PLANNING DIVISION STAFF REPORT-ADDENDUM

July 22, 2013

Project Address: 529-557 State Street, 431-441 North Frances Street, and 432 West Gilman Street

Application Type: Demolition, Rezoning, and Conditional Use

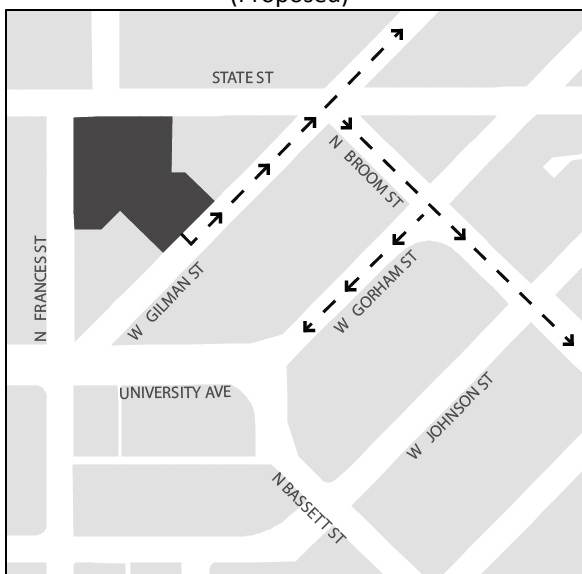
Parking - In a revision dated July 17, 2013, the applicant has added significantly more bicycle parking within the structured parking area, and has included a “flex” area for moped and automobile parking in the northern portion of the first floor of the parking area. The applicant has indicated that the July 17 revision is still a work in progress, but demonstrates that the space for bicycle and moped parking can be accommodated. One expected change in final plans submitted for staff review is that the support columns currently shown to impede access to parking stalls will be relocated.

There are now a total of 439 bicycle stalls in the structured parking area, which is 75% of the 586 stalls required by the zoning code for the residential uses in this building. Of these, 76% are on the first floor. 14% are standard two foot by six foot stalls on the floor, 11% are vertical racks on the walls, and 75% are stacked racks, which results in a wide variety of storage options for tenants based on whether their bicycles are used for daily transportation or occasional recreation. The applicant is also proposing 398 bicycle storage spaces within the residential units, based on previous experiences with tenants storing bicycles within their units. Finally, the July 17 revisions show 20 outdoor bicycle parking stalls within the Frances and Gilman Street rights-of-way. Details for these stalls will need to be coordinated with city staff.

The “flex” moped area is not detailed at this time to show the actual stalls, but a staff believes that the area (which is shown as 28 automobile parking stalls) can indeed accommodate approximately 140-150 moped stalls, which can reach the one stall per seven bedroom ratio advised in the staff report. Final plans submitted for staff review should show this area clearly delineated for moped use. If, based on a survey of incoming tenants, the applicant can show that some of the spaces are not necessary, they can be converted to automobile stalls

following a minor alteration of the conditional use. Assuming the “flex” area is completely utilized for mopeds, the total number of automobile stalls in the parking area will be 116. If the “flex” area were to be completely utilized for automobiles, this would be increased to 144 stalls.

This revised parking plan is much improved, and while it will still require a bicycle parking reduction granted by the Zoning Administrator, staff is much more comfortable supporting it, and believes that it helps the project to better meet Conditional Use Standard No. 5 as it relates to the adequacy of parking.
